PROPOSED S4.55(8) MODIFICATIONS LIST:

VPM
9-11 VICTORIA PARADE, MANLY, NSW

DRAWING TITLE		PROJECT	
SECTION A A		VPM	
SCALE	STATUS	NUMBER	REVISION
1:200	S4.55 (8)	A3.02	A

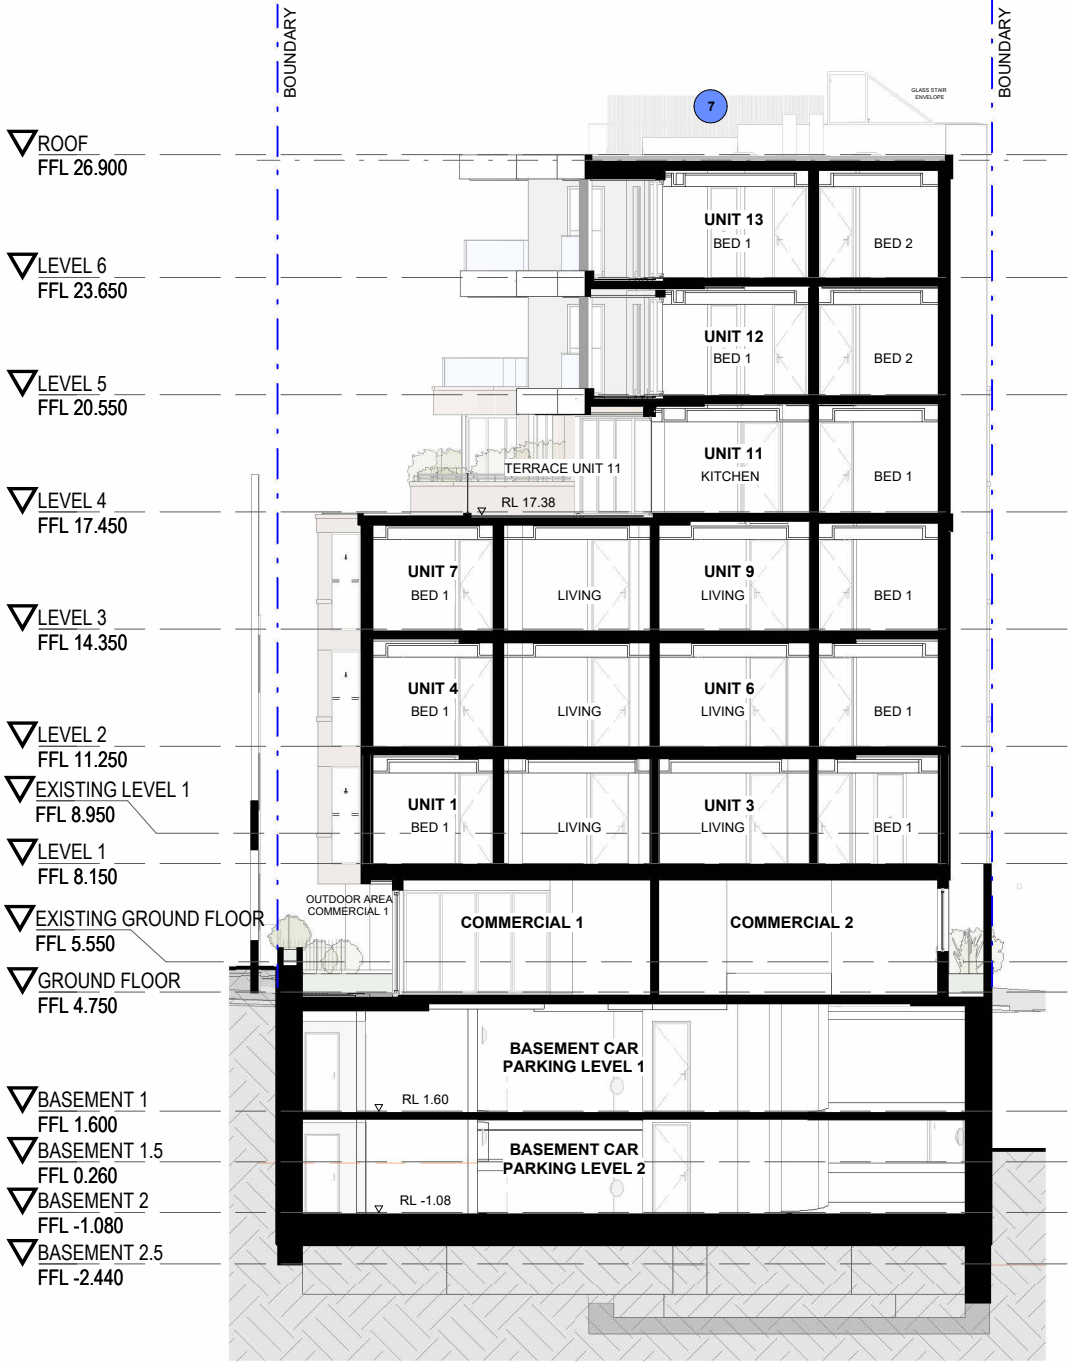
- Retail 1 on Ground floor has been pushed out to enhance the usable area and to suit new columns for balconies above.
- The front facade's angle has been adjusted to enlarge the front balconies and comply with ADG regulations of balcony size.

- Front balconies on level 1 and level 2 were extended to the north east to align with the approved balconies above to avoid looking 'top-heavy' and unbalanced.

- Level 4 brick wall shifted to align with adjacent brick walls.
- Cladding colour proposed to be off-white to visually lighten the bulk of the upper floors.

- Allocation of 1 bicycle space per unit in large storage cages in lieu of separate bicycle parking to satisfy the intention of condition 43D.
- Private roof terrace introduced to improve amenity of unit 14. The glass stair enclosure is not readily visible from the street and has no real impact on privacy, bulk or overshadowing.

- Increase in width of high-light windows to improve ventilation and natural lighting in the bedrooms with no privacy impacts.
- Minor adjustment to the GFA due to the above– still less than LEC approved FSR 3:1.

- Window heads have been lowered to 2.58m to fit services
